**N6746B-01**

**S E R V I C E N O T E**

**N6746B 100W DC Power Module**

**Current Measurement accuracy is out of specification when there is voltage being sourced at the output terminals.**

Location of C36 and C37

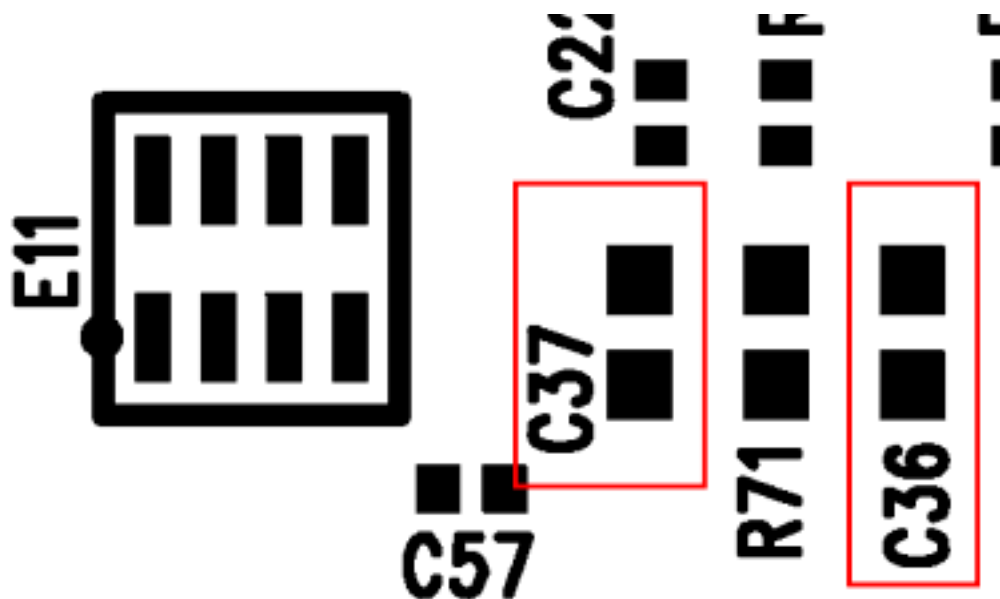
Due to some noise filtering issues, the current measurement accuracy will be out of specification by a fixed offset when there is a voltage being sourced at the output terminals. If the output is shorted, the current measurement accuracy will be within specifications. Please note that the performance verification test will not catch this.

If this measurement is out of specification, replace capacitors C36 and C37 on the DPM assembly (this is the assembly that is vertically mounted in the unit that looks similar to a PC memory module) with part number 0160-7809. After the capacitors are changed, the unit will require re-calibration. After the capacitors are replaced, check the make sure that the unit is in specification by applying 75% of the full voltage range while attached to a load drawing 50 mA to 70 mA. If the current measurement is within the specification, then the unit has been repaired.
